SERVICE INFORMATION LETTER NO. 0046

Subject: Damper Modification

Model: F-28A, F-28C, 280 & 280C

Effectivity: Serial No. 003 thru 321; also 325, 326, 327, 331, 332, 334, 337, 338, 339, 340
Serial No. 1001 thru 1030

Figure 1

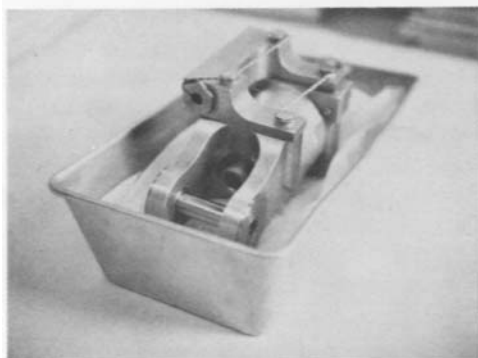
- b. Remove the safety wire from the four reservoir retaining bolts and plug. Place the damper assembly on its side, with the reservoir and retaining bolts facing up, in a clean shop pan or on a clean shop cloth (see Figure 1).

Figure 2

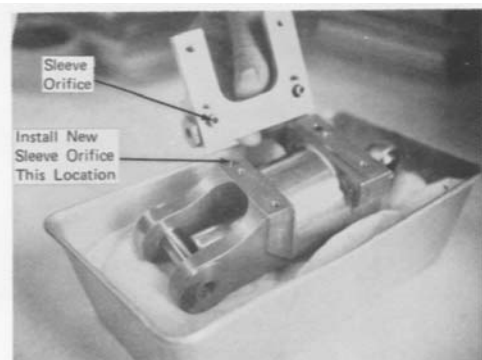
- c. Remove plug from reservoir end, remove the four reservoir retaining bolts, and lift reservoir from the damper housing. The position as described in paragraph (b) should be maintained so as not to allow air to enter the piston cavity. Oil loss from the reservoir will be replaced on assembly. It should be noted that discoloration of the silicone oil is common and should be disregarded. See Figure 2.
